**ISSUE:** Certificate of Appropriateness for alterations

**APPLICANT:** City of Alexandria represented by Lisa Lettieri, Architect

**LOCATION:** Old & Historic Alexandria District  
301 King Street

**Minutes from October 16, 2025 BAR hearing**

## MARKET SQUARE PLAZA PLAN - ARCHITECTURAL MATERIALS

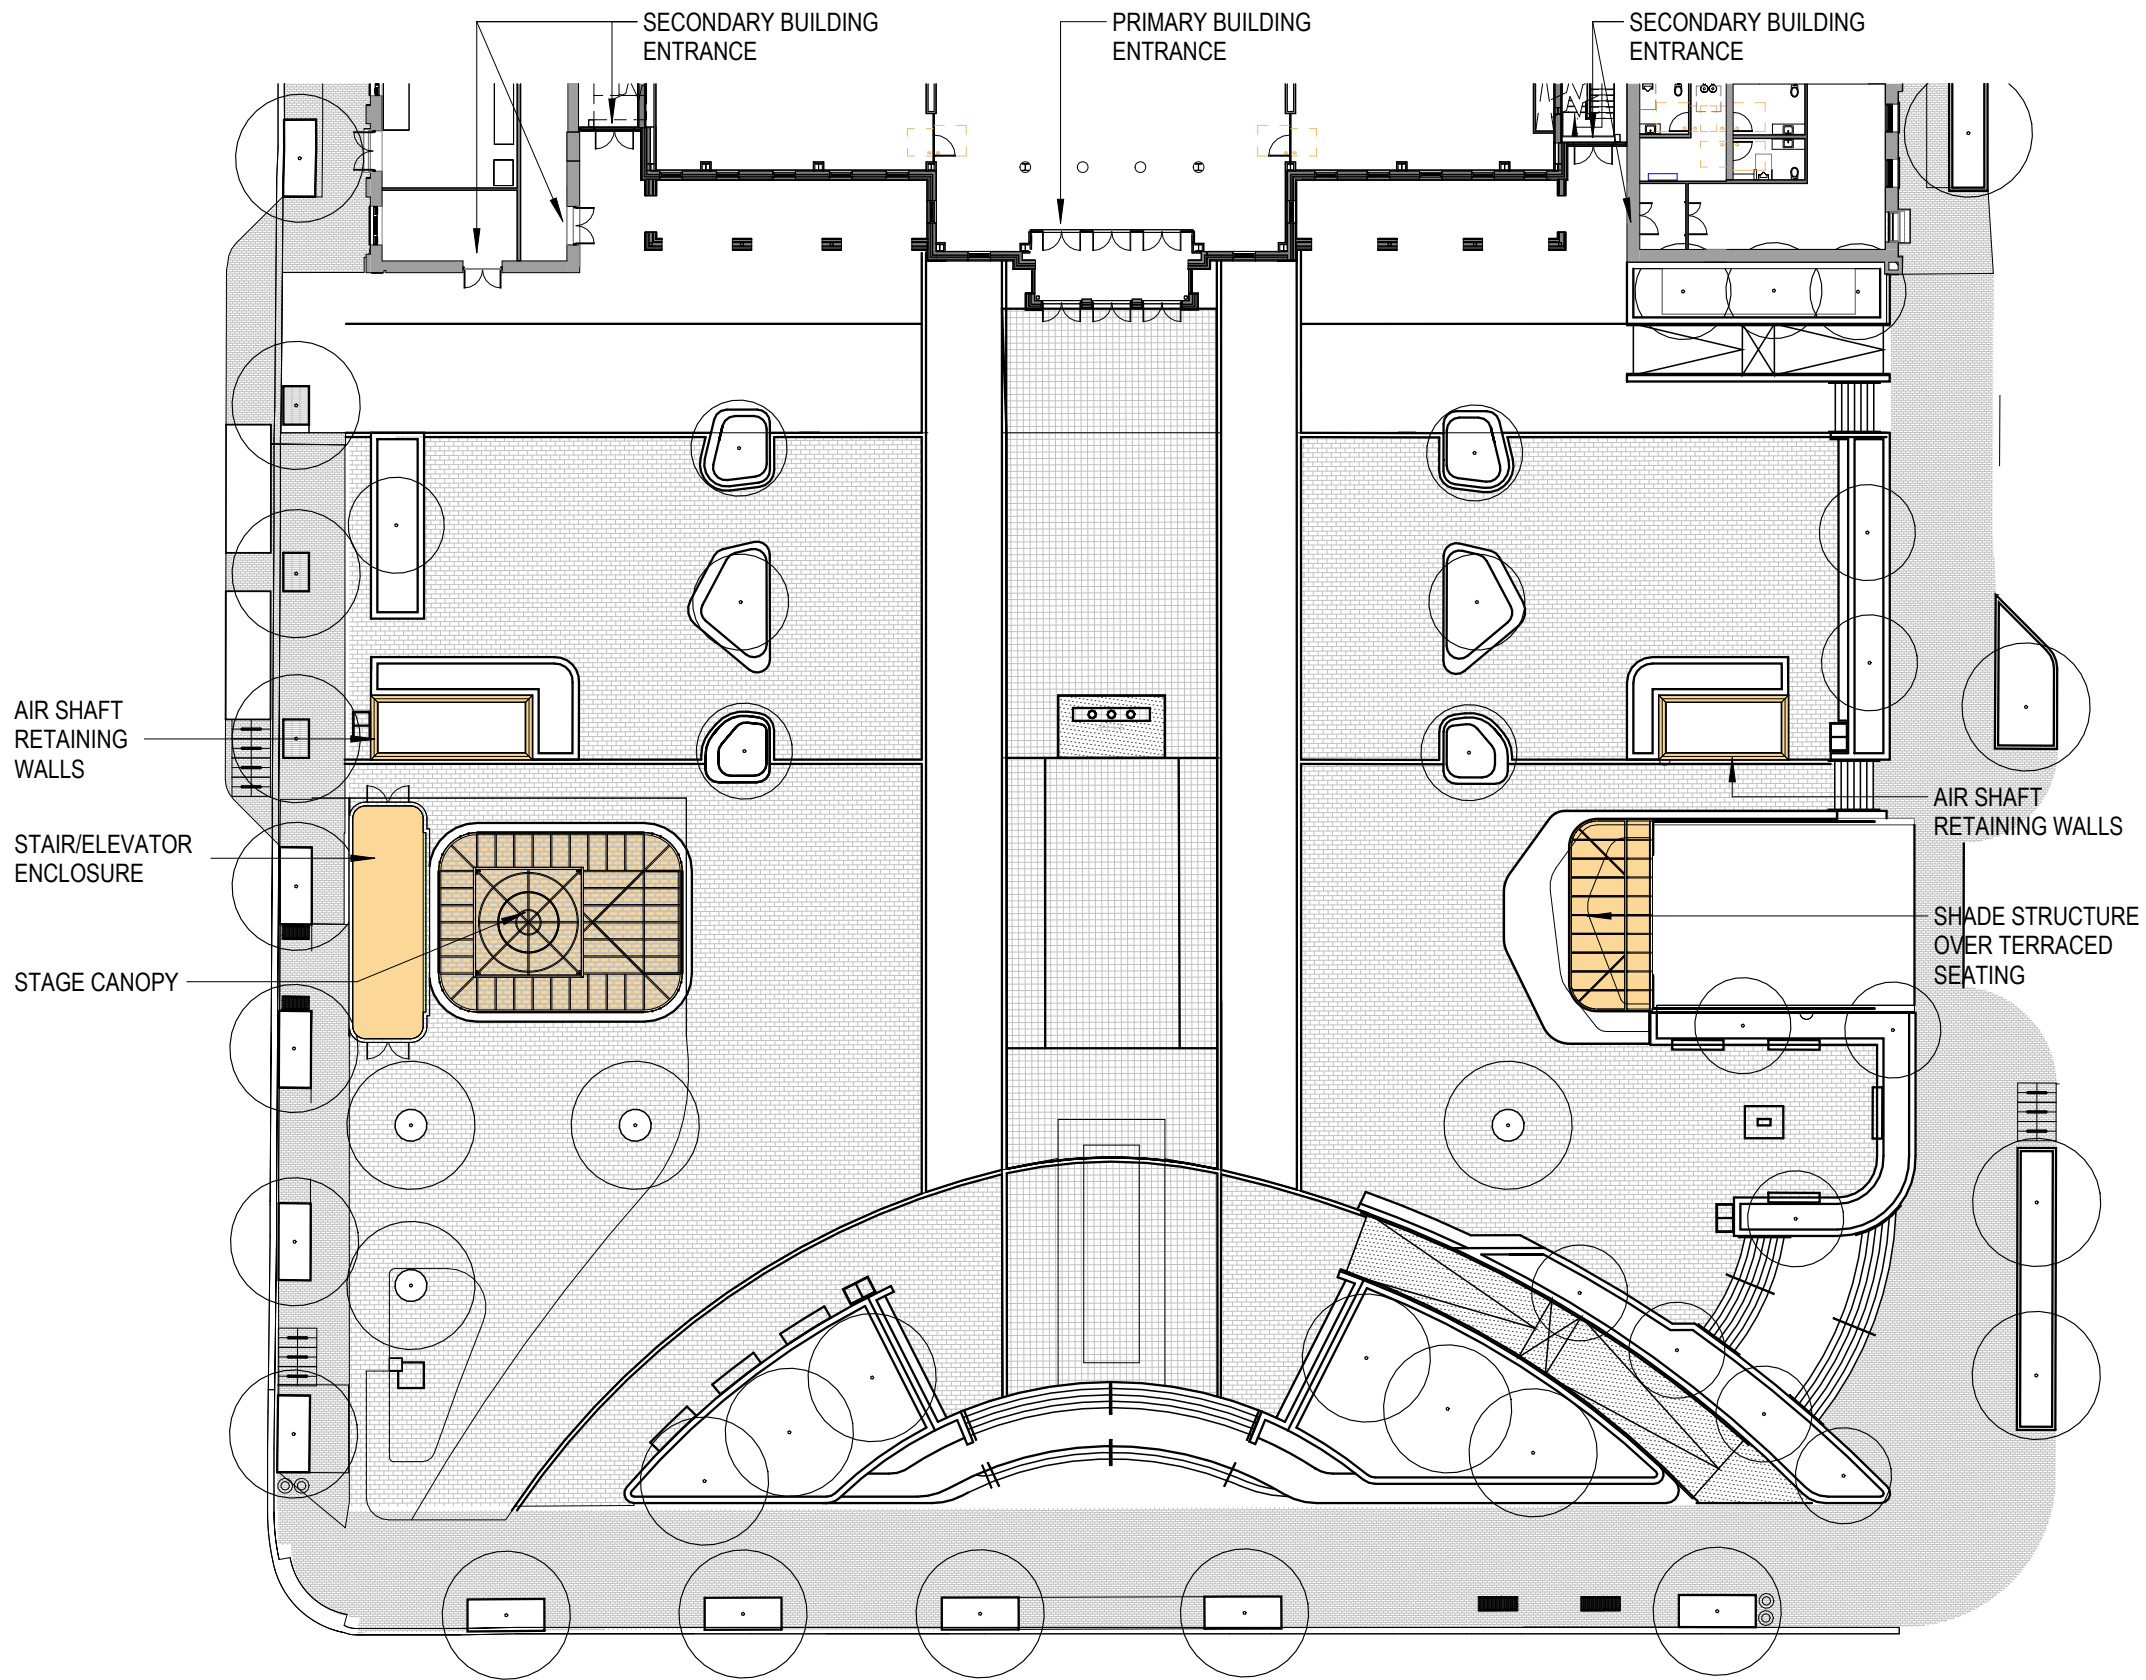
At the last BAR hearing, Board members expressed concern regarding the amorphous shape for the seat height planters at the north east and north west corners of the plaza, the design for the shade structures and the design for the elevator enclosure. Their concern was that the design for these structures was not compatible with the design for the building because of their informal expression. The shade structure at the west side of the plaza was supported by the Board and they asked the design team to develop a design for the shade structure on the east side of the plaza that was similar in lieu of the more sculptural structure that was presented. Regarding the design for the elevator enclosure, Board members noted the curved corners and placement of metal panels adjacent to grade.

In response to Board comments, the design team has revised the design for these elements to be more formal, similar to the architecture of the building. The raised planters are now rectilinear elements with rounded corners. The elevator enclosure has been simplified and is now a rectilinear element with a stone base (Figure 6). The shade structure on the east side has also been simplified and more closely resembles the shade structure on the west side (Figure 7).

In the revised design, the raised planters have become rectilinear with gentle curved corners. The shade structure on the east side of the plaza is now similar in design to the one on the west side, featuring a flat roof with solid and obscured glass panels and a wall at the east side shielding the plaza from the garage entry ramp. The elevator enclosure has been modified to include stone at the base of the structure and square corners.

PROPOSED HYPHEN DETAILS

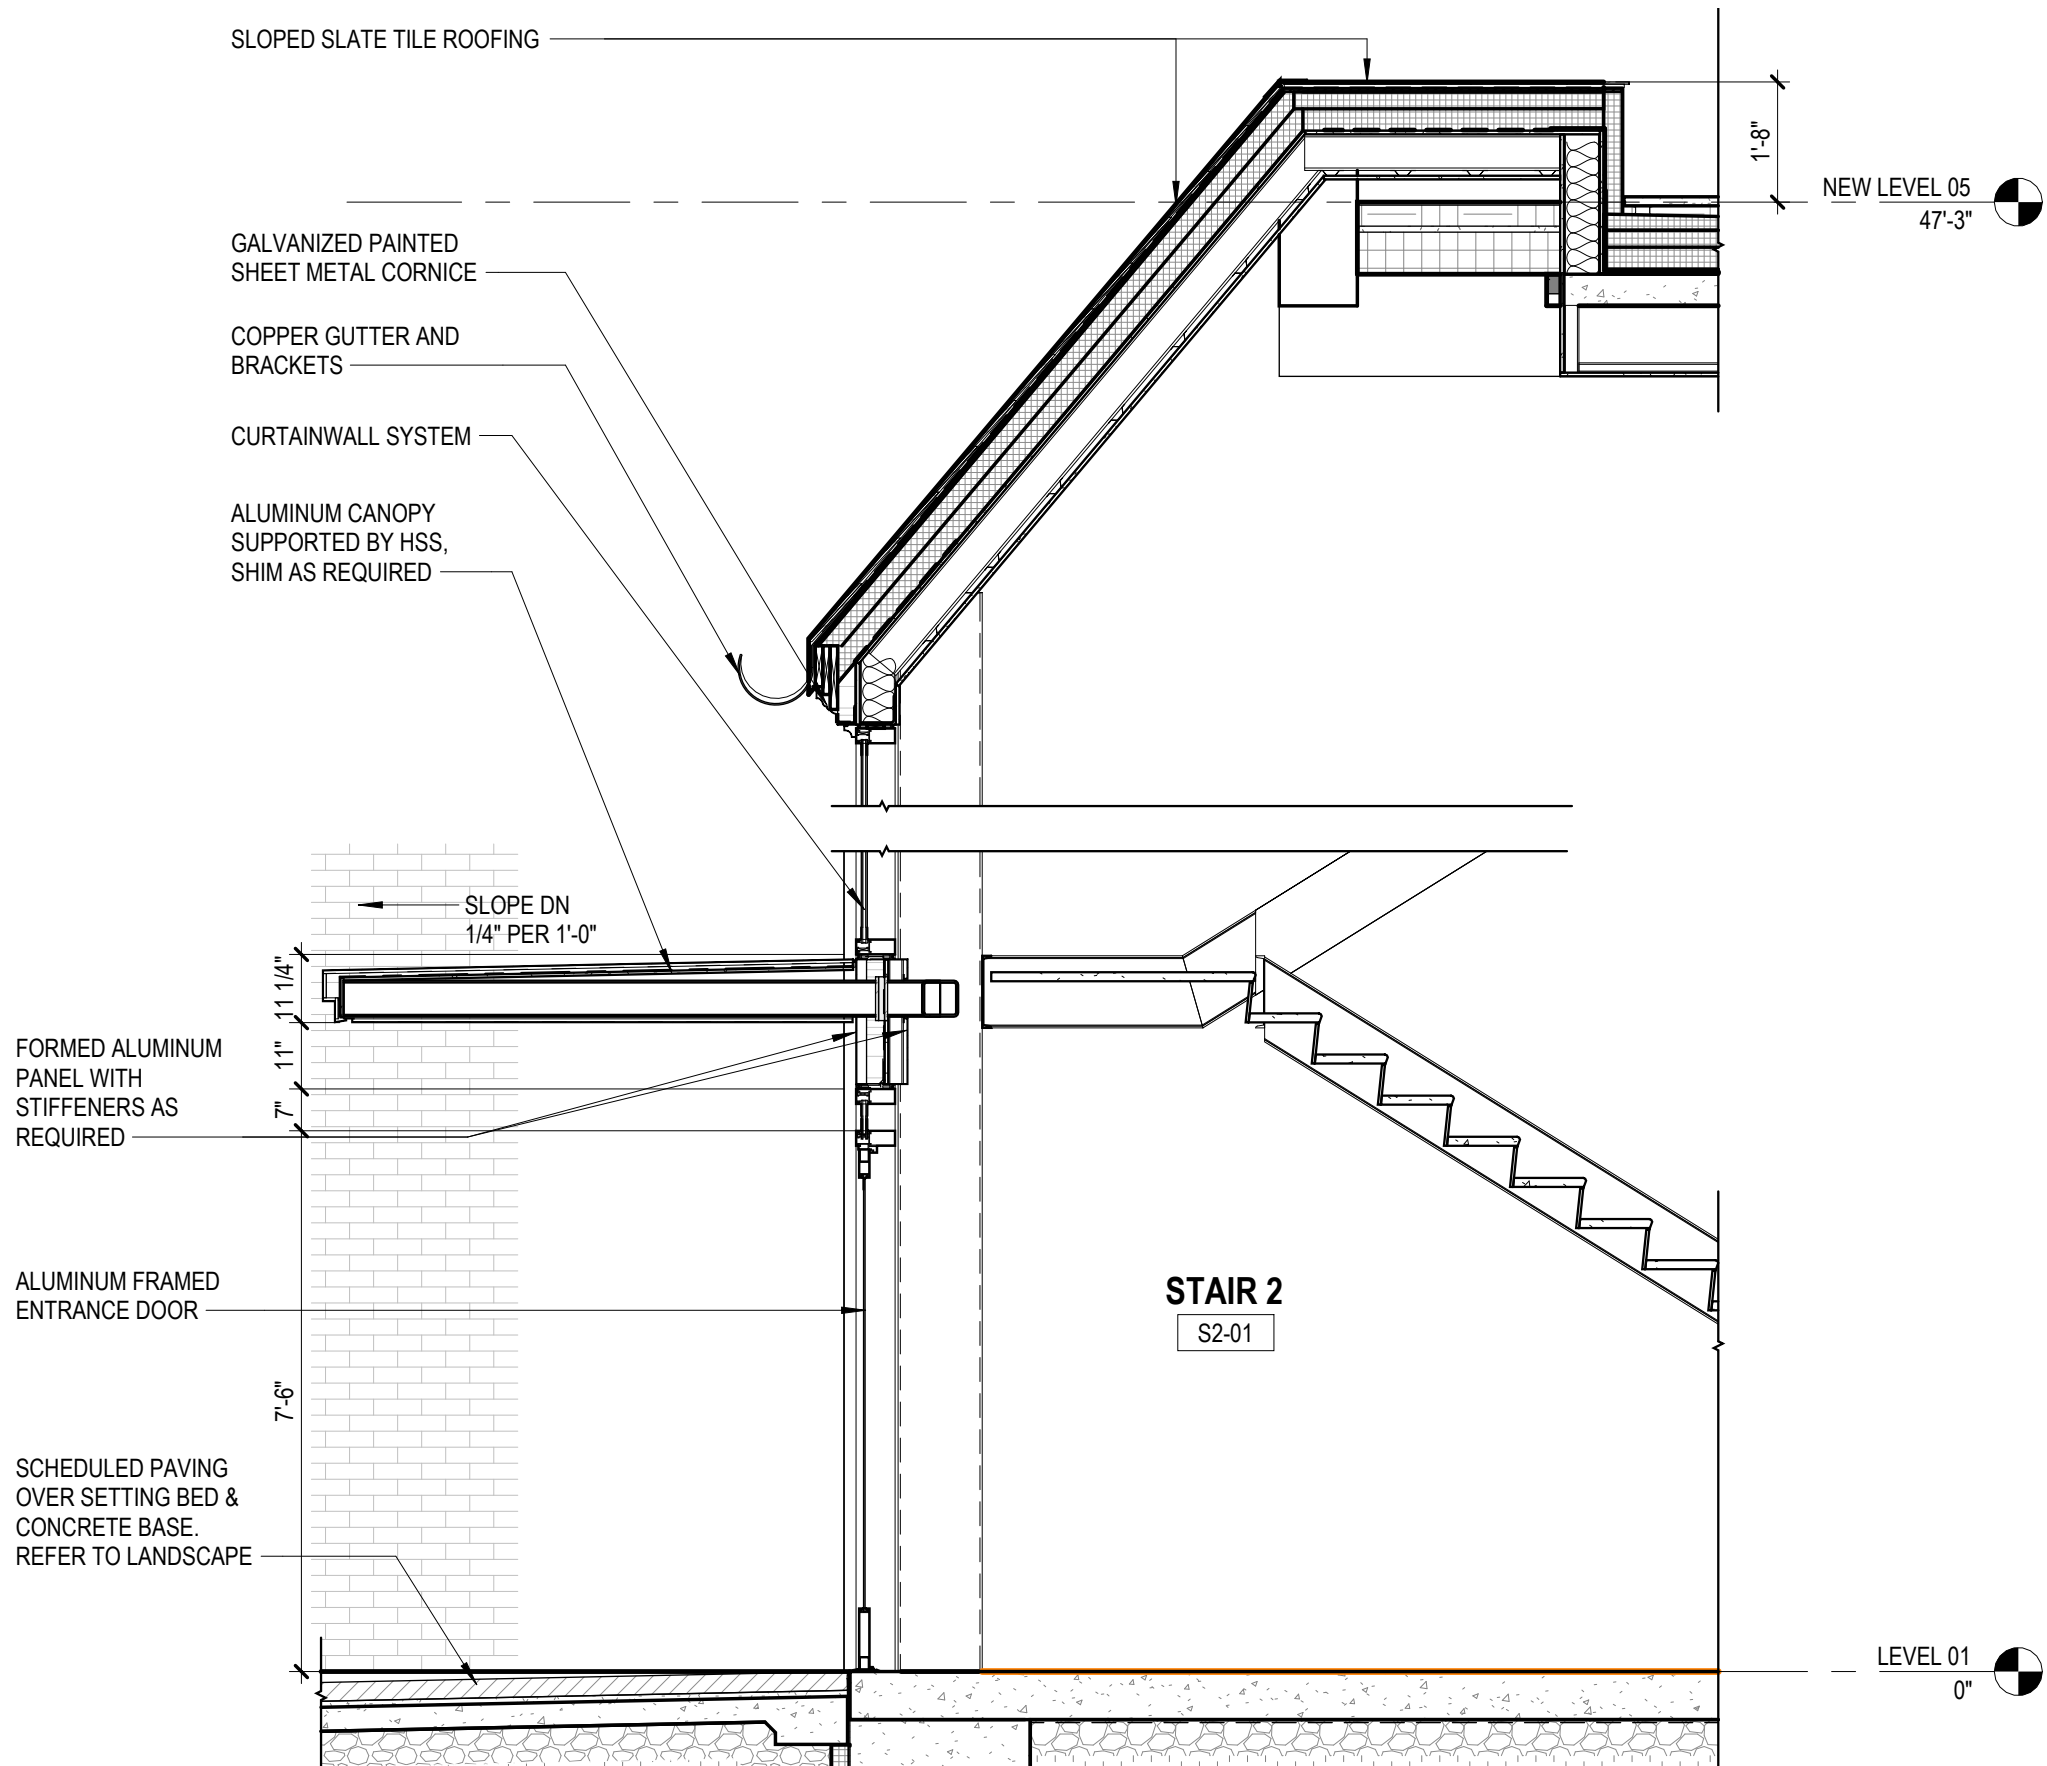
John Patrick, HARC, appreciated the scope of restoration on the building. He prefers the new design for the building entrance but opposes the use of full height glazing at the hyphens, preferring a solid wall in this location. He also expressed concern regarding the extent of glazing at the fifth floor.

Melissa Kuennen, NOTICE, recommended that the design team continue to revise the design similar to proposals made by members of the public, stating that the proposed design for the central portion of the south elevation is not consistent with the overall building design. She noted that the entrance is awkward and that the glazed hyphens are incompatible with the overall building design.

In a number of previously approved additions, the Board has supported the use of a vertical slot of some sort to provide the prescribed differentiation between the historic and a later addition. The proposed modifications to the east and west ends of the 1961 addition create this vertical slot by “offsetting the footprint” of the building setting the face of the hyphen a significant distance behind the face of the addition. The use of full height glazing on this component addresses the *Design Guidelines* direction not to “obscure or dilute the architectural and historic importance of an existing building” by allowing for the original exterior wall of the 1871 portion of the building to be visible from the exterior. Staff supports this approach as consistent with the Design Guidelines and with previously approved additions.

OPTION 4A – REVISED  
TWO STORY EXPRESSION OF BRICK PILLARS AND CORNER QUOINS

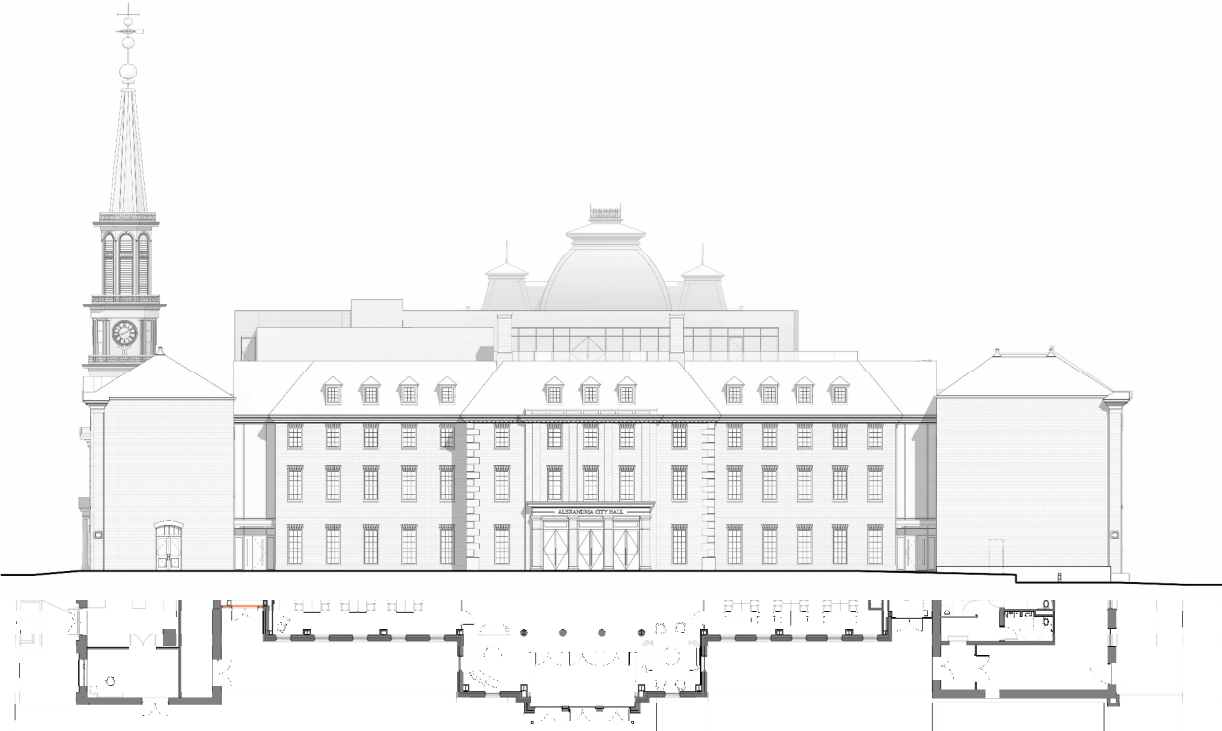
Ms. Zandian stated a preference for the quoins to be of alternating sizes and for the dormers to be smaller. She supported option 4B without the arcade. Regarding the plaza, she supported the use of rectilinear planters and a more traditional design for the shade structures.

In previous BAR hearings, Board members have expressed an interest in having the south elevation of the City Hall building modified to include a prominent building entrance that is reinforced with a strong central building expression. At the BAR Work Session, the design team discussed options for this element with the Board including the introduction of pilasters above the entry element that could be rendered in either brick or stone. At the top of these pilasters is a decorative balustrade similar to the existing configuration. In all options, the hip roof form is restored in a more simple form than in previous submissions. Each of these design options includes an alternate with and without chimneys similar to the one currently in place.

In response to Board comments, the design team is presenting several options, all of which retain the hip roof form adjacent to the hyphen and restore the original roof form at the central part of the elevation. In all options the entry element has become more consistent with the style of the 1961 addition and pilasters have been added to the wall above the entry extending through the cornice line, creating a roof element that reinforces the verticality of this section of the building. Option 4A (Figure 3) has these pilasters rendered in brick while Option 4B (Figure 4) and 4C (Figure 5) have stone pilasters of differing colors. Each option is being shown with and without chimneys.
